CITY OF BLOOMINGTON
2016-201 NORMANDALE BLVD STREET IMPROVEMENT PROJECT
SP 107-020-65
SP 027-634-009
STPM 2716 (052)

Issued: August 8, 2016

The Contractor shall note the following changes and clarifications included in this Addendum #1. Plan sheets 1, 4, 10, 23A-23D, 64, and 81 have changed and are issued with this addendum. Plan sheets 2, 3 and 17 have changed, but are **not** reissued with this addendum.

SHEET NO. 1 OF 200

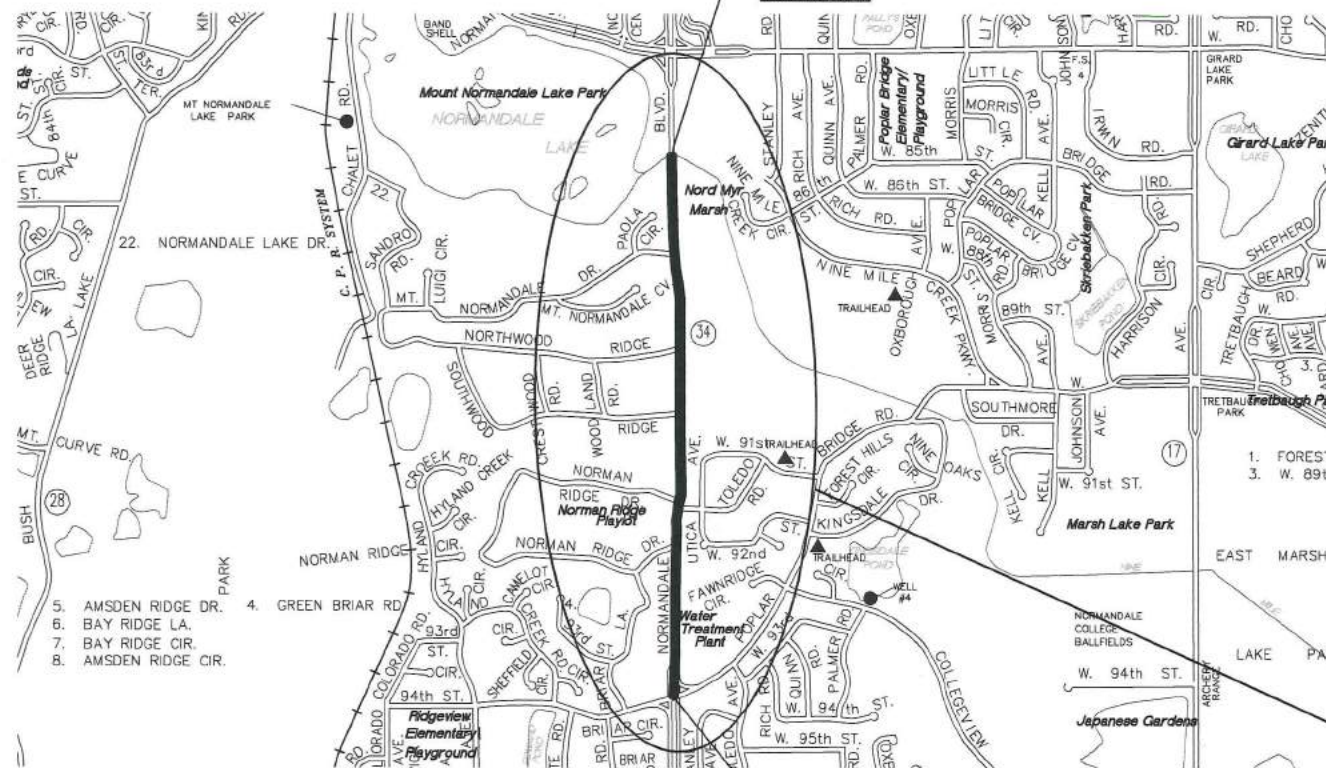
1. Sheet No. 1 is hereby deleted and preplaced with the attached Sheet No. 1. This sheet is being reissued for the updated index which now includes 204 sheets.
 - Changed the sheet number to 17-23D for the Details & Standard Plates under the Index.

- Changed the total number of sheets to **204**.
2. Sheet No. 2 is hereby modified. A replacement sheet is not being issued.
 - Add a Planned (P) Quantity to 2105.523 Common Borrow (CV) (P). The total quantity remains at 1194 CY.

SHEET: 10 OF 200

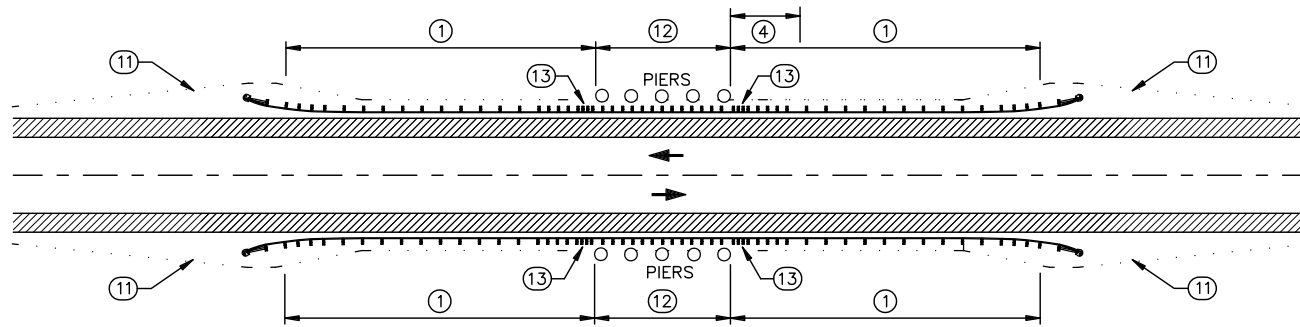
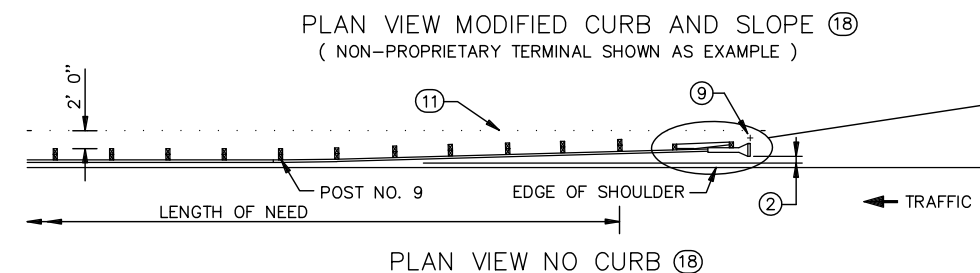
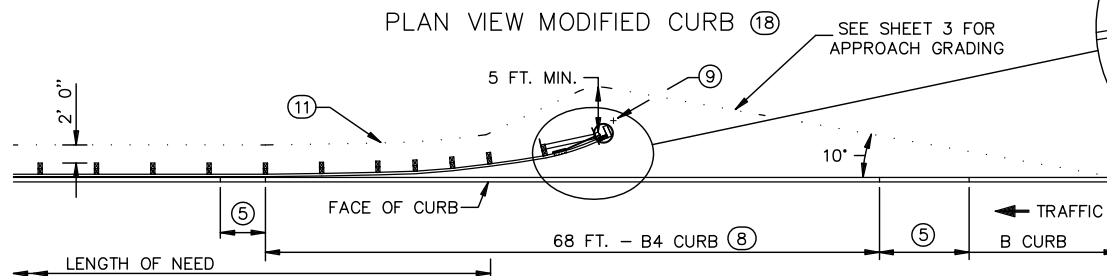
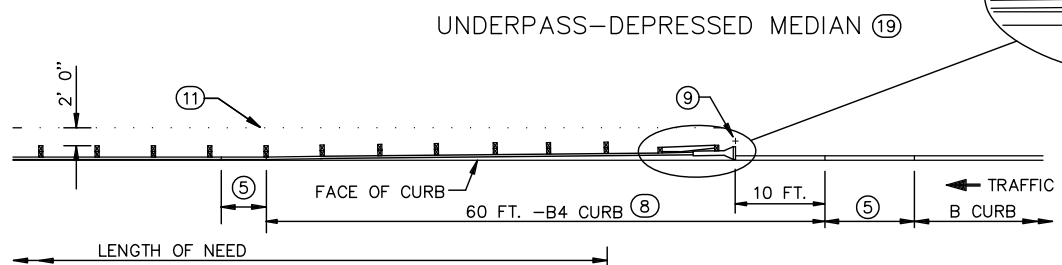
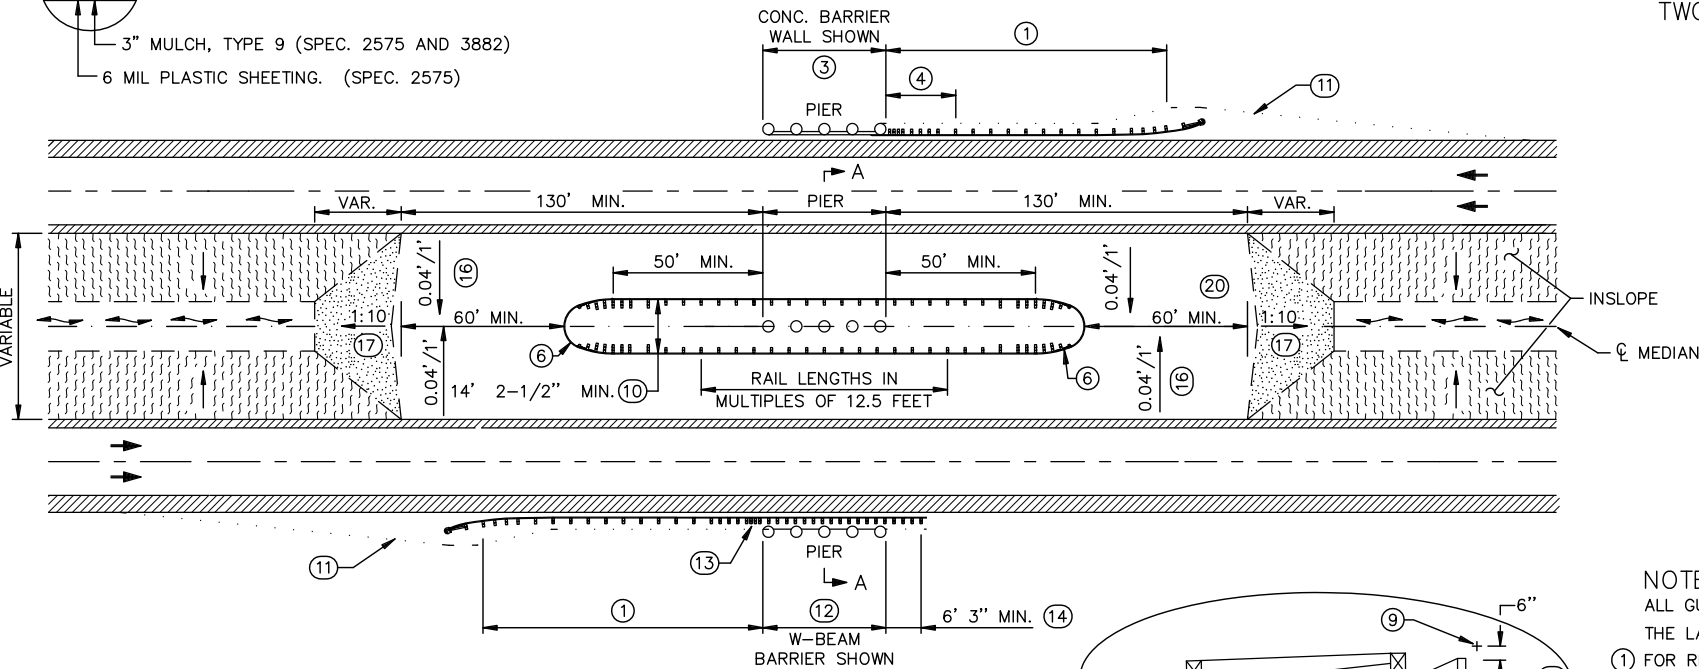
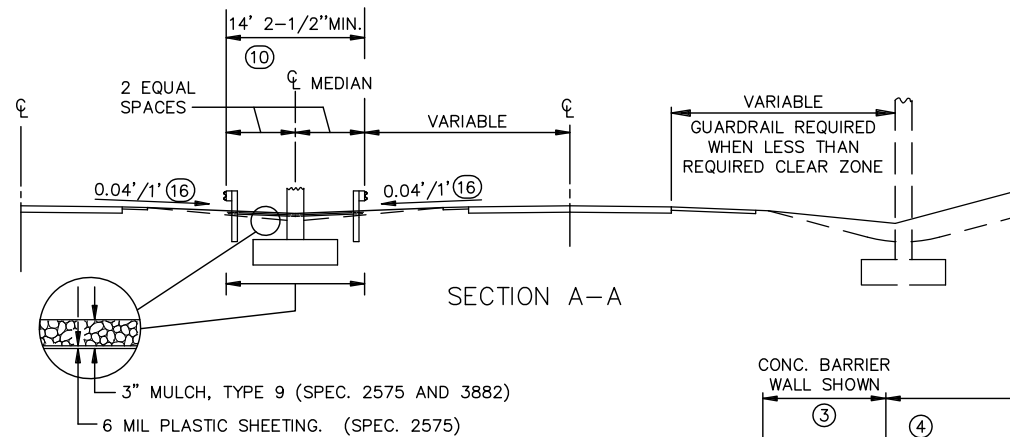
- Changed the quantity of 2554.615 "Relocate Impact Attenuator" to 7 Amby
 - Changed Note 17 "Shall be CAT-350, Brakemaster or X-MAS"
 5. Sheet No. 10 is hereby deleted and replaced with the attached Sheet No. 10, dated 8/8/ 2016 in the Revision Block. This sheet is being reissued to update Tab J with the revised guardrail information as listed on the SEQ.

TRAFFIC BARRIER DESIGN SPECIAL

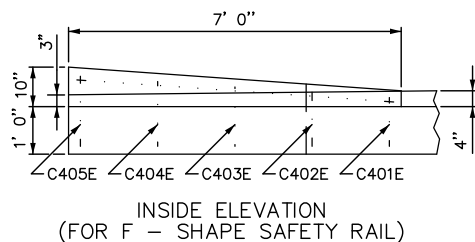
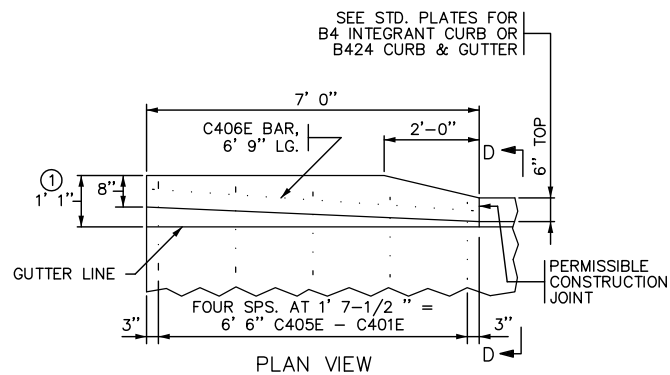
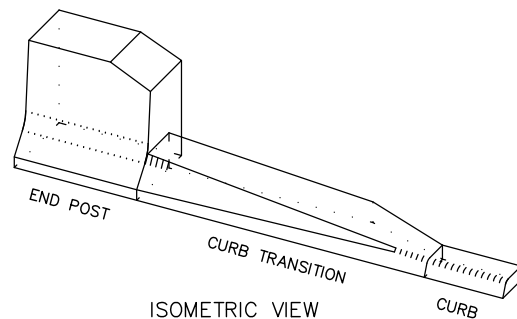
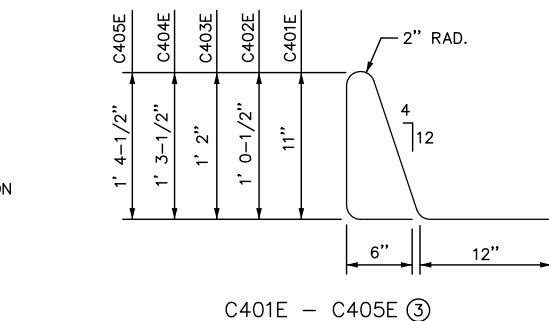
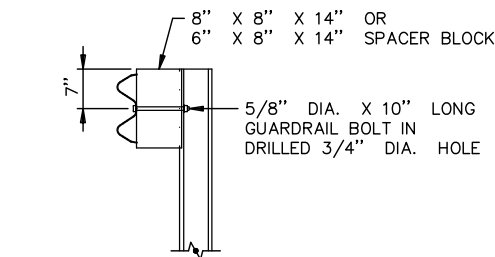
7. Sheets 23A-23D are hereby added to include the MnDOT Standard Plans: Guardrail Installations at Medians (3 sheets) and Guardrail Installation at Medians and End Treatments (1 sheet)

SHEET:
64 OF 200

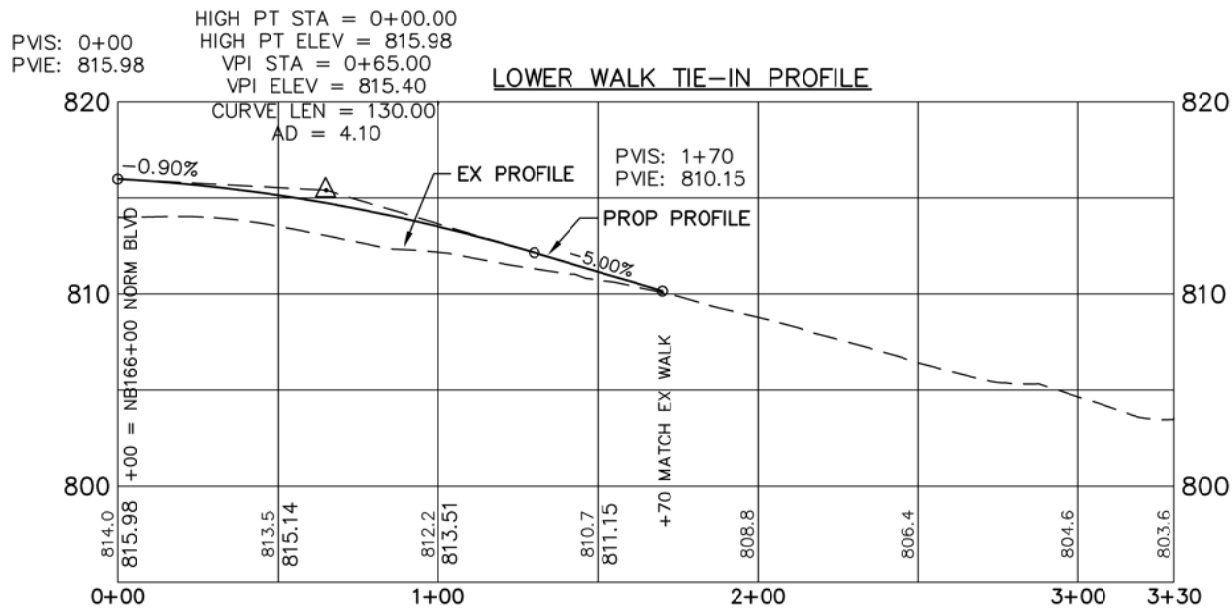
8. Sheet No. 64 is hereby deleted and replaced with the attached Sheet No. 64, dated 8/8/2016 in the Revision Block. This sheet is being reissued to modify the note regarding the Traffic Barrier Design Special and End Treatment – Energy Absorbing Terminal.

UTILITY PLAN
NORMANDALE BLVD (CSAH 34)
FROM STA 120+50 TO 128+00

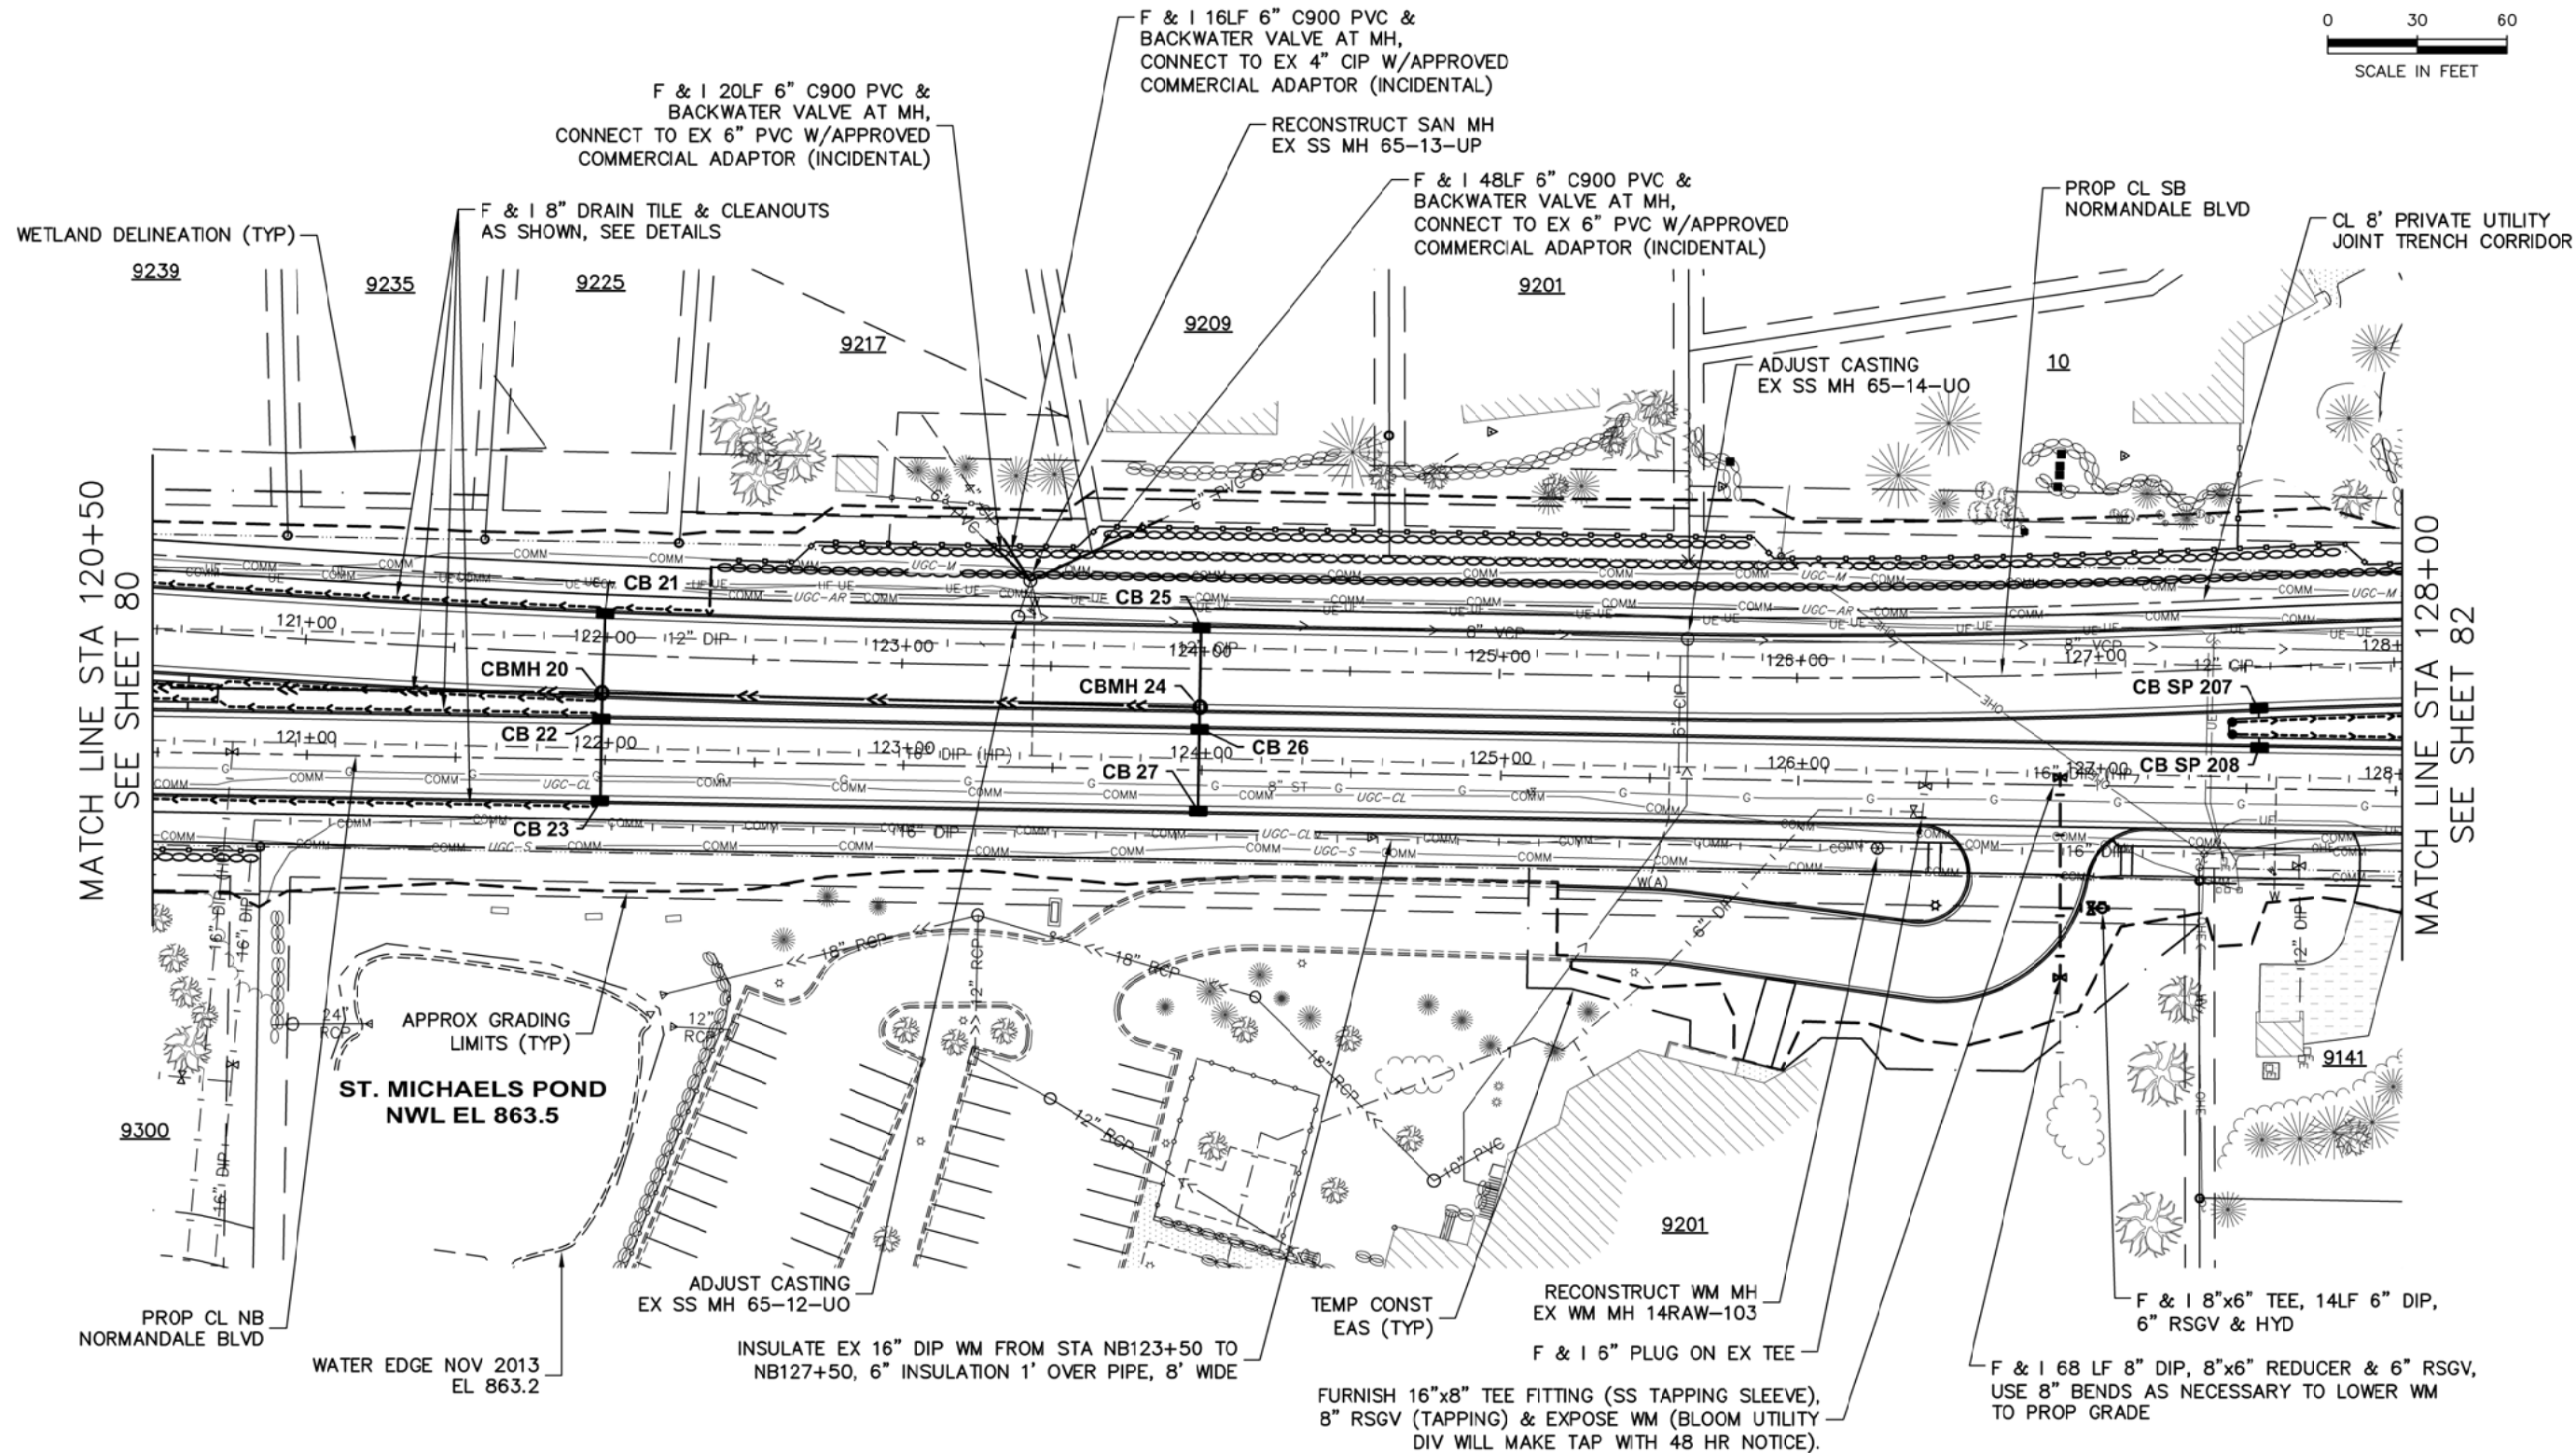
9. Sheet No. 81 is hereby deleted and replaced with the attached Sheet No. 81, dated 8/8/2016 in the Revision Block. This sheet is being reissued to modify the fire hydrant location at the church driveway 5' to the east.
